I found 3 omissions in the Kiss schematics in the English Manual.

Kiss "Plug Connectors" W1187-10 Schematic

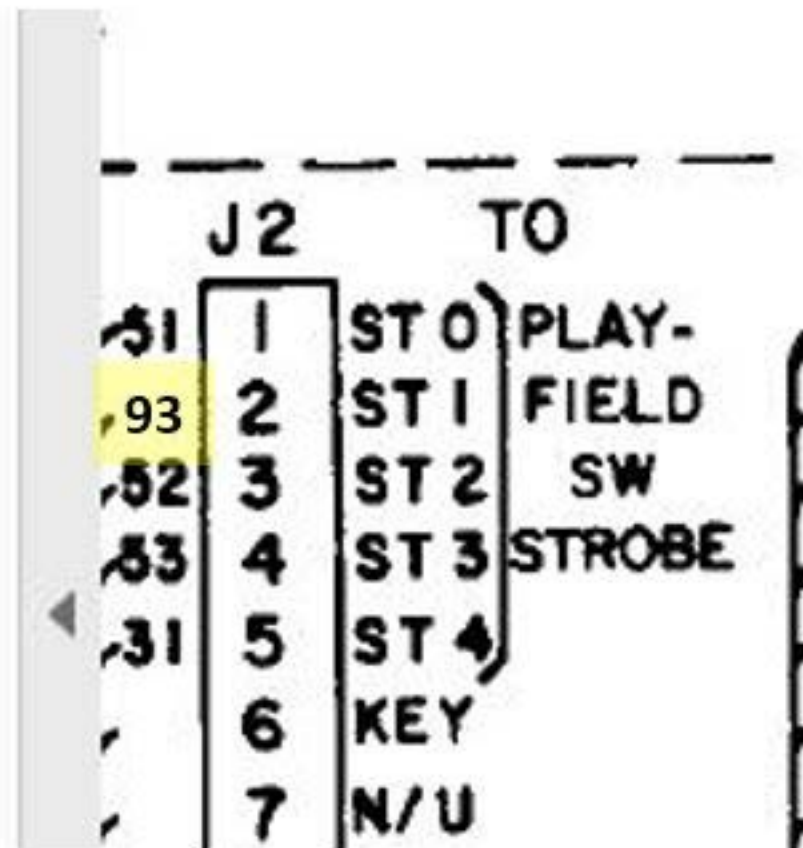
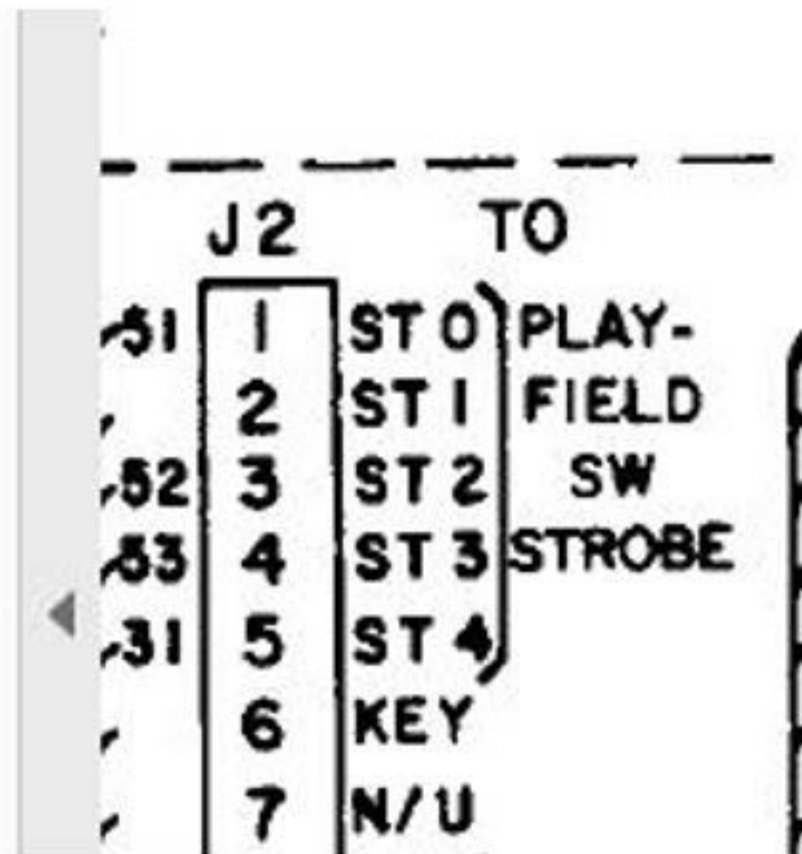
On Kiss "Plug Connectors" W1187-10 schematic MPU J2 pin 2 to playfield should have the wire color labeled "93" for a gray wire with a yellow trace.

MPU J2 As Is:

Should Be Added:

ST1 is a gray wire with a yellow trace.

Kiss "Plug Connectors" W1187-10 Schematic

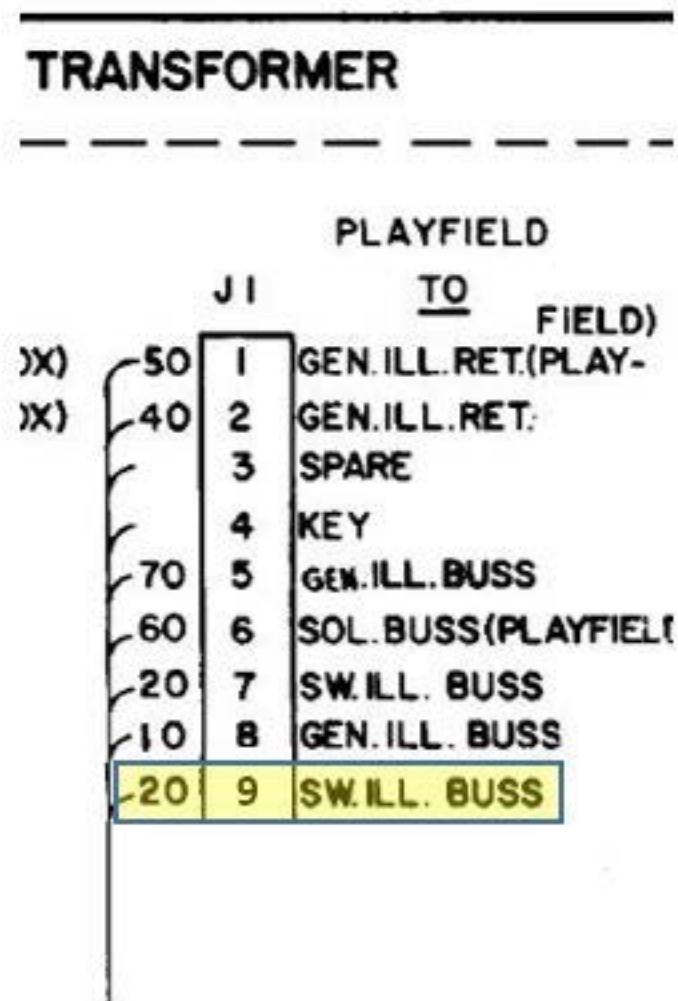
On Kiss "Plug Connectors" W1187-10 schematic Transformer J1 to playfield should have pin 9 added with a "20" for wire color (blue) and should be labeled "SW. ILL. BUSS", the same as J1 pin 7.

As Is:

Should Be Added:

Kiss "Switch Matrix" W1192-10 Schematic

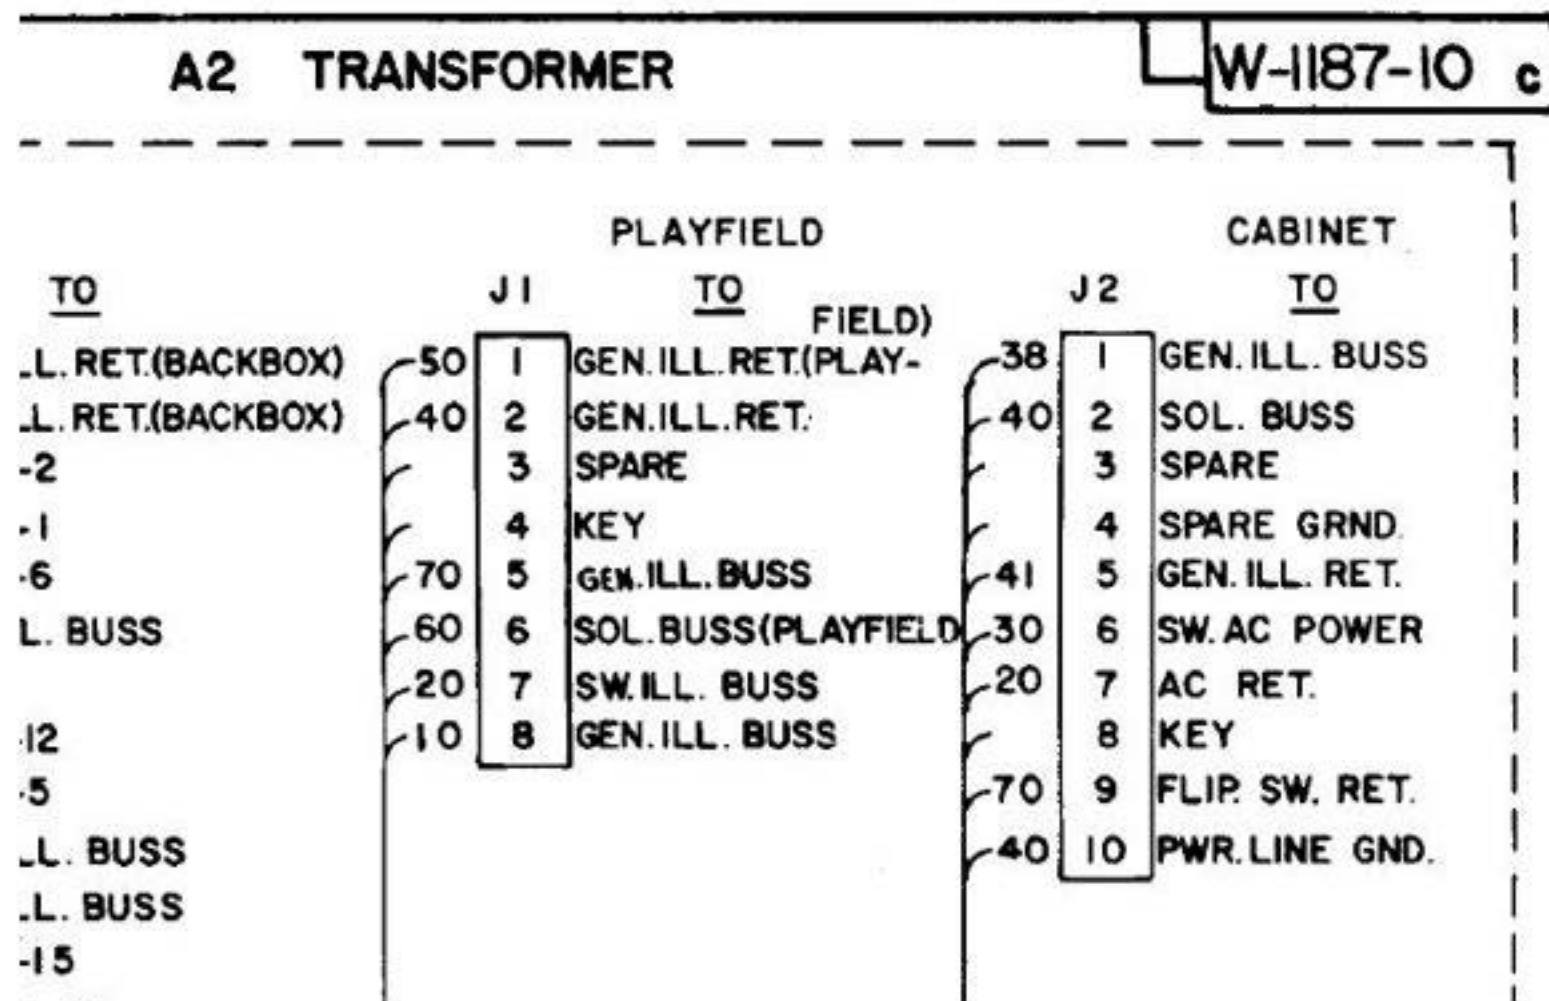
On Kiss "Switch Matrix" W1192-10 Schematic beneath the line "20----A2J1-7 Feature Lamp Buss" should be another line reading "20----A2J1-9 Feature Lamp Buss".

Top As Is:

Bottom Should Be Added:
